Ref. FOI2015/04585

I am writing to inform you that the MOD objects to the proposal. Our assessment has been carried out on the basis that there will be 1 turbine, 48.01 metres in height from ground level to blade tip and located at the grid reference below as stated in the planning application or provided by the developer:

Title: WR80026/01
DIO 21766 – AIR TRAFFIC CONTROL (ATC), AIR
DEFENCE (AD), MAA RADARS AND RANGES –
ASSESSMENT OF THE DEVELOPERS
PROPOSAL TO ESTABLISH A WINDFARM AT
BANNAUDUON, NEAR LLANARTH

BANNUADUON (DIO21766) WIND FARM DEVELOPMENT PROPOSAL - NO OBJECTIONS

Figure 1
OFFICIAL

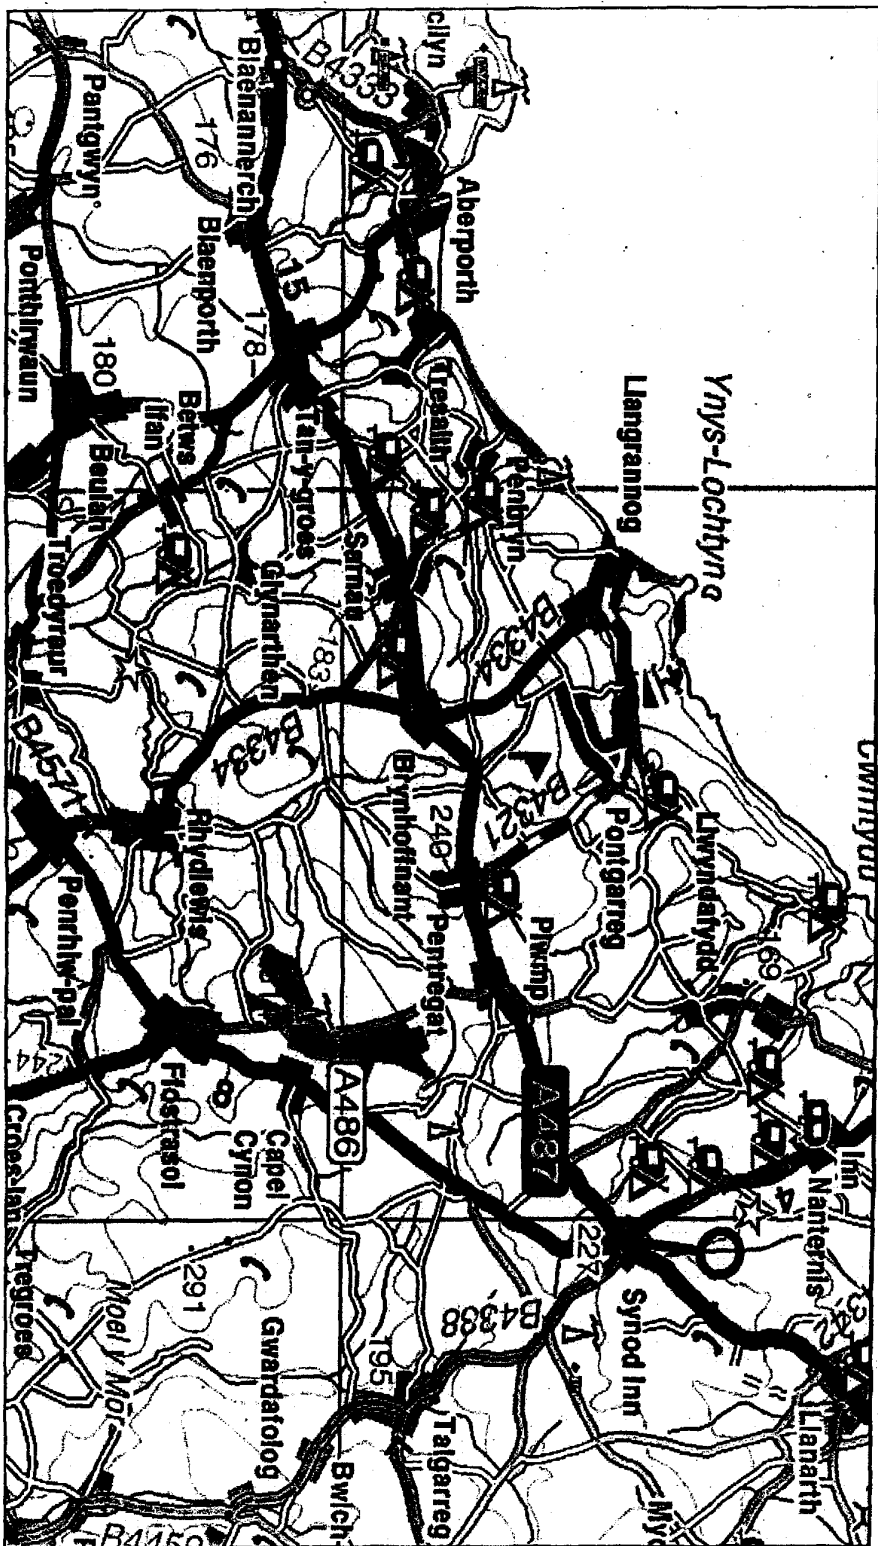
2.1 Reference A is a proposal to establish a wind farm of 1 turbine at Bannauduon, near Llanarth. National Grid References were provided for all positions (SN (2)42049 (2)53548). The highest point of the turbine blades will be 48 metres above ground level. A local map of the proposed area is shown at Figure 1.

Figure 2
OFFICIAL

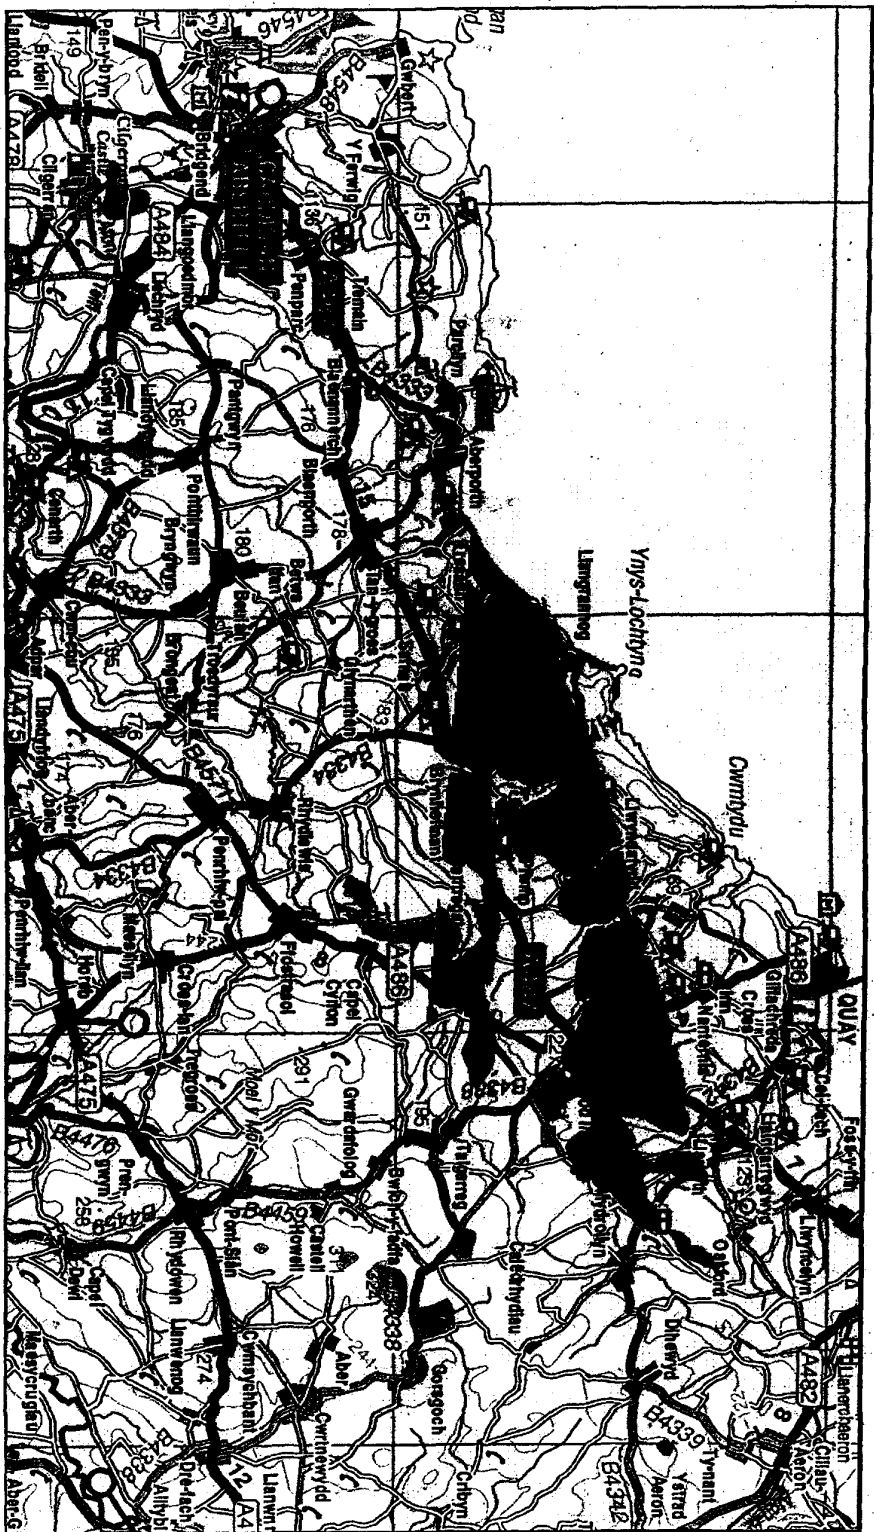
4.1.1	Range to Windfarm:	18.162km
	Angle to Windfarm:	85.26°
	RLOS Visibility	20m
	Turbine RCS:	20.5m ²
	Aux Beam:	Inside

4.1.2 A Field Strength Coverage plot was generated for the radar using these parameters (Figure's 2 & 3), indicating that the turbine will be detected by the radar.

It is recommended that the Operations Staff check whether the proposed wind farm at Bannauduon is in an area of vital air traffic operations controlled by the radar at Aberporth. If so a decision to object to the proposal should be considered on the grounds referred to in paragraph 3.1 and paragraph 3.2.

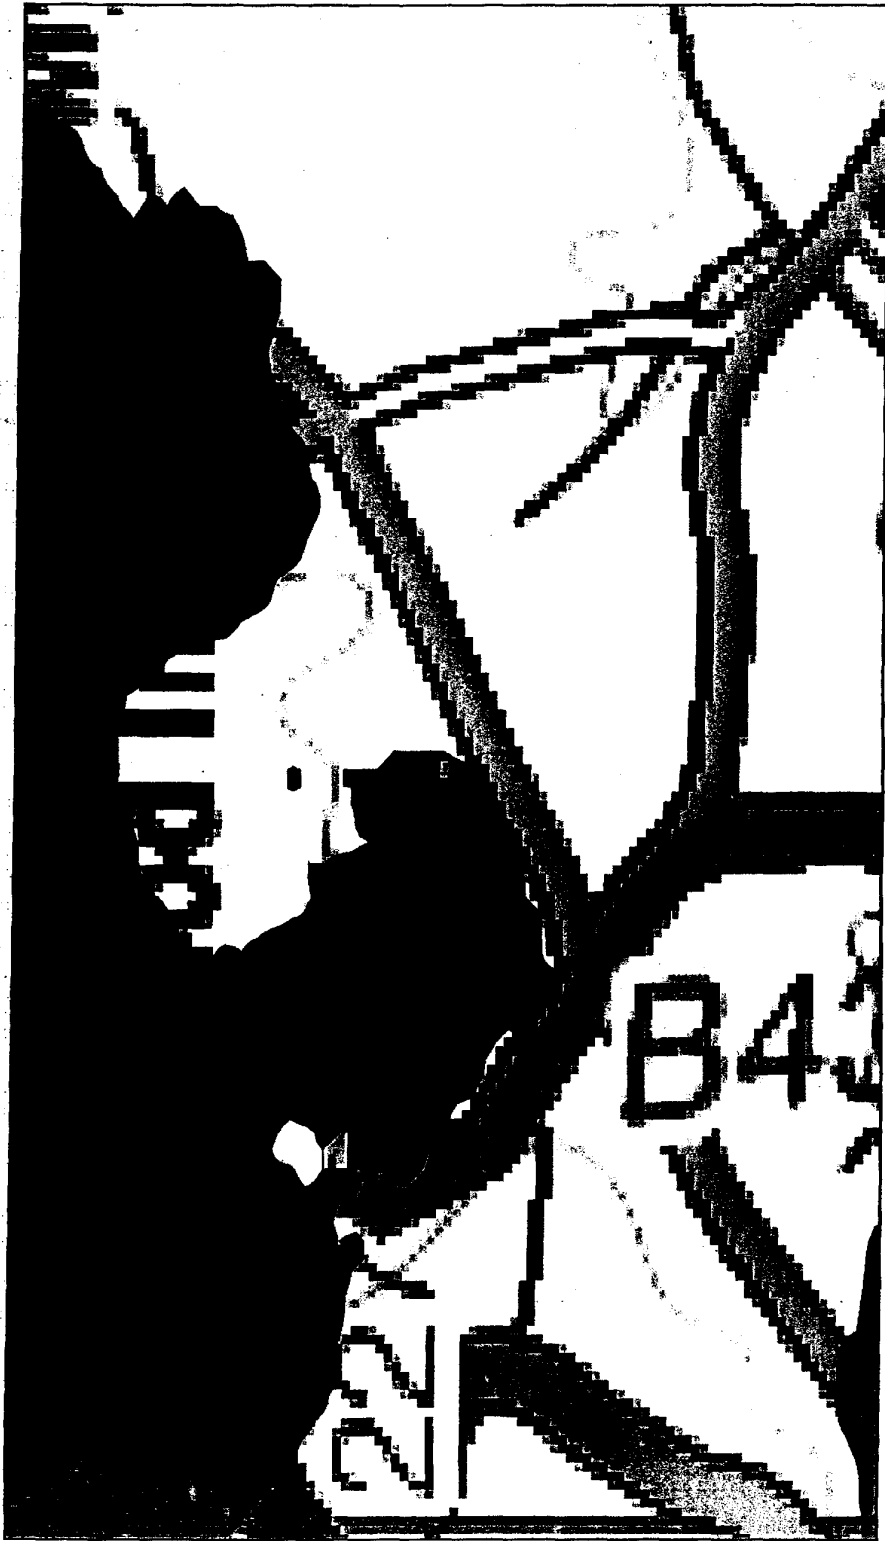
Further to our conversation earlier this morning, with regards to an objection that the MOD will be lodging with Ceredigion Council in relation to the above planning consultation. The technical advisor has stated there may be a possible mitigation solution. I have attached a coverage map showing that the turbine will be detectable by the Range Control radar at Aberporth. If the turbine was moved slightly to east out of the blue shaded area this would take it out of radar line of sight.
